## SUTHERLAND SHIRE COUNCIL ASSESSMENT REPORT

Panel Reference	PPSSSH-70
DA Number	MA21/0080
LGA	Sutherland Shire
Proposed Development:	<b>S4.56 modification to DA18/0323</b> – involves modifying the ground floor private open space areas, minor internal changes, window modifications, change to booster location, increase in height and floor space ratio, change to façade cladding and amendments to landscaping.
Street Address:	<b>S/P 545, Lots 1 to 3 S/P 9336, Lots 1 to 4 S/P 48254, Lots 4 to 6 S/P 67206 – 5 to 9 Ozone Street, Cronulla</b>
Applicant/Owner:	<b>Ozone Cronulla Pty Ltd</b>
Date of DA lodgement	<b>17 February 2021</b>
Number of Submissions:	<b>1</b>
Recommendation:	<b>Approval</b>
Regional Development Criteria (Schedule 7 of the SEPP (State and Regional Development) 2011	This application is referred to the SSPP as this application is an application made under Section 4.56 of the Environmental Planning and Assessment Act 1979 and is a modification to an application previously heard by the SSPP and approved by the Land and Environment Court. As this application is made under Section 4.56, it is required to be determined by SSPP.

Report prepared by:	<b>Bagnall M, Sutherland

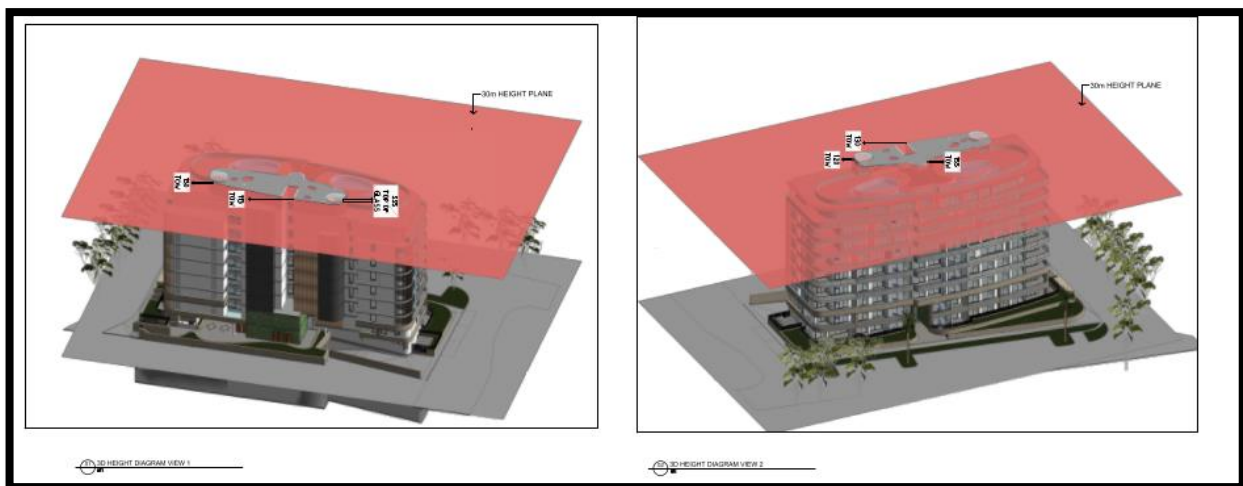
The architect also questioned whether the carpark exhaust outlet at the back of the lift complies with the required separation distances to habitable areas, i.e. the terrace level swimming pool for example.

The applicant provided additional information confirming the stair pressurisation intake is to be within the retaining wall of communal open space at the rear and the car park supply air intake is to be in the western wall facing the driveway (This is discussed in the 'Assessment Section' of the report). With regards to the height of the roof terrace level, reducing the flooring to ceiling height from 2.3 to 2.1m will bring it closer to numerical compliance and a condition has been included requiring the ceiling height to be reduced. (Building Height has been addressed in the Assessment Section)

Height Blanket show non compliant portions of the building.

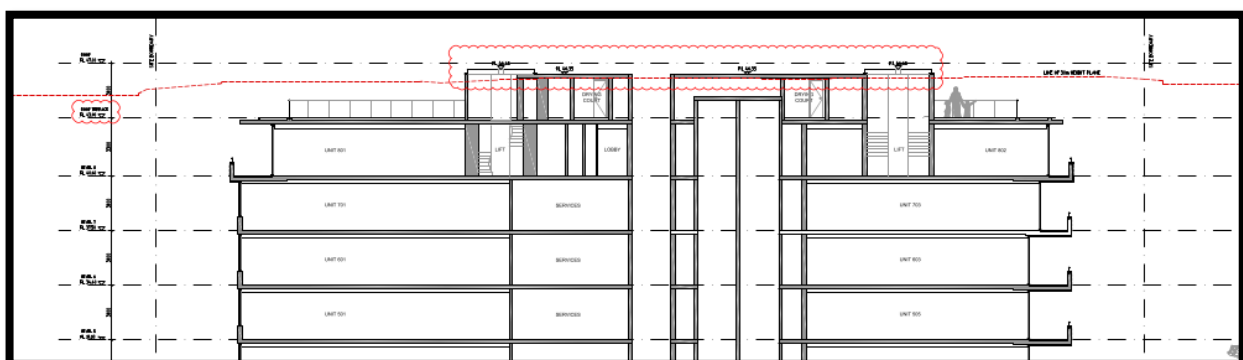
The proposed development fails to comply with the development standard for height. Clause 4.3(2) of SSLEP 2015 stipulates a maximum height of 30m for the site. The proposal seeks a building height of 30.63m which exceeds the maximum height by 630mm, resulting in a 2.1% variation. The roof elements that exceed the building height standard is the upper roof (RL46.35) and glass roof (RL46.65) over the internals stairs of units 801 and 802.

Top of Section C showing the portions of the building exceeding the maximum building height.

The height will not likely exacerbate the bulk and scale of the building form when viewed from surrounding properties and the street as the non compliant sections of the building is adequately setback from the boundaries of the site and toward the centre of the site and therefore will unlikely change the visual impact of the building form. The proposal is considered acceptable in terms of impacts on adjoining or nearby properties from loss of views, overshadowing or visual intrusion and is recommended for approval.

View from unit 1001/20 Gerrale Street (plan SK002 – View impact analysis sketch) with the red hatched line showing the increase in height.

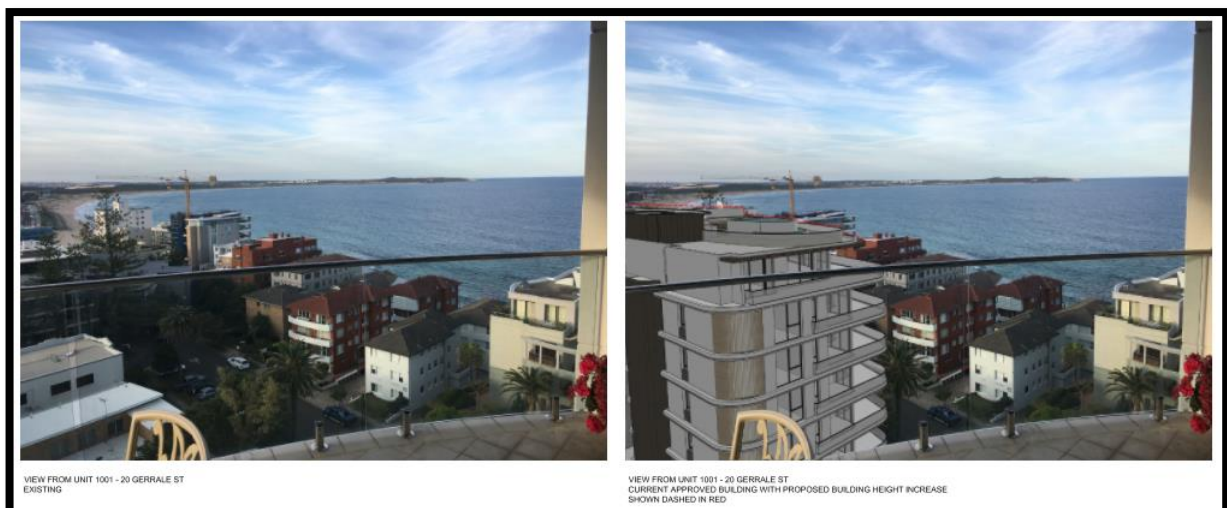
The modifications sought retain the approved building footprint, however proposed with an increase in height of the roof and new glazed roof over the internal stairs. The applicant provided photos from 3 units at 20 Gerrale Street (The Cecil Apartments) to demonstrate the increase in height will not have a significant impact on views to be retained with the approved development.

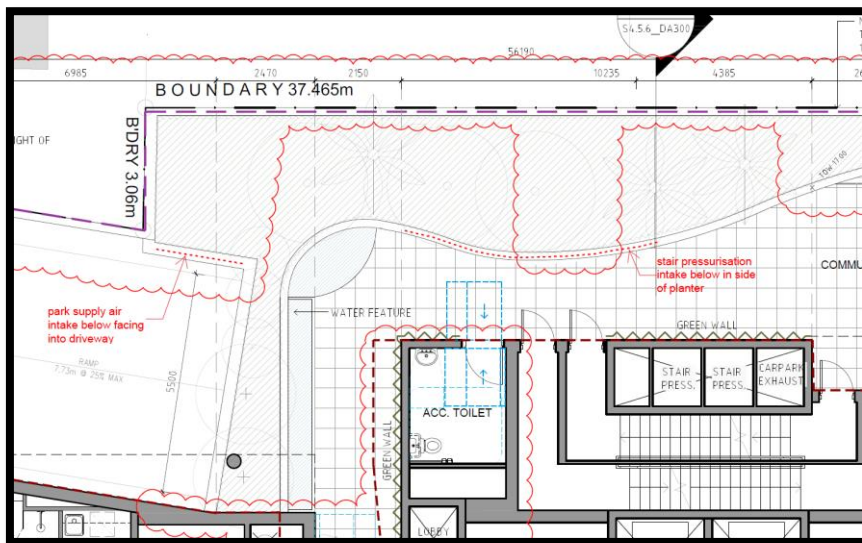
High palisade fencing is proposed with the wall of the ground floor private open space areas, around the southern side of the temporary bin holding area and the north western end of the communal open space areas. The private open space areas are proposed to move forward on the site and therefore to ensure the fencing and landscaping sits comfortably within streetscape, a condition is recommended requiring the combined height of the wall and palisade fence to be no greater than 1.5m in height above the finished terrace levels and to be erected only around the bin enclosure (not along the front boundary on Cecil Monro Avenue).

Section of the ground floor plan showing car park supply intake and stair pressurisation intake.

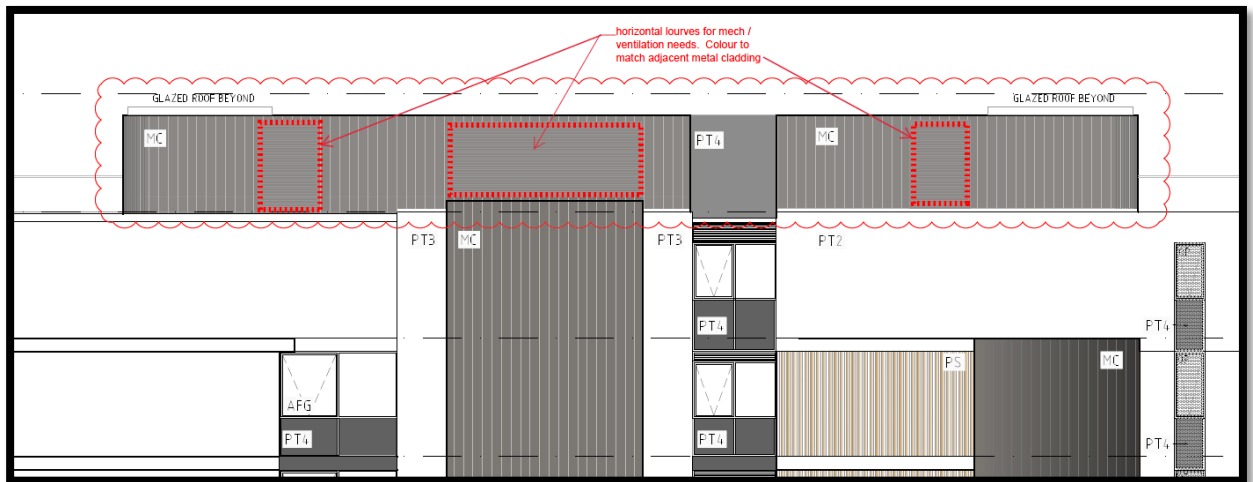
The carpark intake grille has been deleted from the garden bed in the western communal open space area. The grille has been relocated to the western wall facing the driveway and to the side of the planter bed. The mechanical ventilation will not be placed on the roof and is to be provided behind the grilles/louvres on the west elevation, as shown in the following diagrams:

Western elevation showing location of mechanical ventilation
